Access Compliance Report Public Rights-of-Way (Curb Ramps)

Intersection ID: 52933 Main Street: EMORY_OAK_DR Cross Street: WILLOW_OAK_POND_LN Location: S

ADA ID: 60C539086BEC Ramp Type: Perp Initial Pass/Fail: Fail Overall Compliance: No Severity Score: 13.75

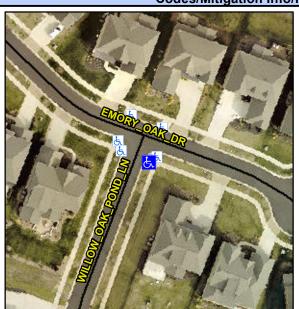
Possible Solutions:	9
Remove & Replace Entire Ramp.	N
•	Y
	N
	N
	N
	N
Surveyor Notes:	N
N/A	N
	N
	N
	N
PROW/ADA:	N
Not Found, R304.2.2, R304.5.3	N
	N
	N

Field Measurements/Component Compliance							
Comp	liance Description	Data	Comp	liance Description	Data		
N/A	Ramp Length (in)	100.0	No	Ramp Slope (%)	9.3		
Yes	Ramp Width (in)	50.0	No	Ramp XSlope (%)	3.7		
N/A	Flare Type LT	N/A	N/A	Flare Type RT	N/A		
N/A	Flare Slope LT (%)	N/A	N/A	Flare Slope RT (%)	N/A		
N/A	Flare Traversable LT?	N/A	N/A	Flare Traversable RT?	N/A		
N/A	Landing Length (in)	N/A	N/A	DWS Provided?	N/A		
N/A	Landing Width (in)	N/A	N/A	DWS Contrast?	N/A		
N/A	Landing Slope (%)	N/A	N/A	DWS Length (in)	N/A		
N/A	Landing X Slope (%)	N/A	N/A	DWS Full Width?	N/A		
N/A	Landing Curb? (Y/N)	N/A	N/A	DWS Offset (in)	N/A		
N/A	Shared Landing?	N/A					
N/A	Gutter Ponding?	N/A	N/A	Gutter Slope (%)	N/A		
N/A	Gutter Lip Ht (in)	N/A	N/A	Gutter X Slope (%)	N/A		
N/A	Painted X Walk1?	No	N/A	Painted X Walk2?	N/A		
	X Walk 1 Direction	To NW		X Walk 2 Direction	N/A		
N/A	X Walk 1 Width (in)	N/A	N/A	X Walk 2 Width (in)	N/A
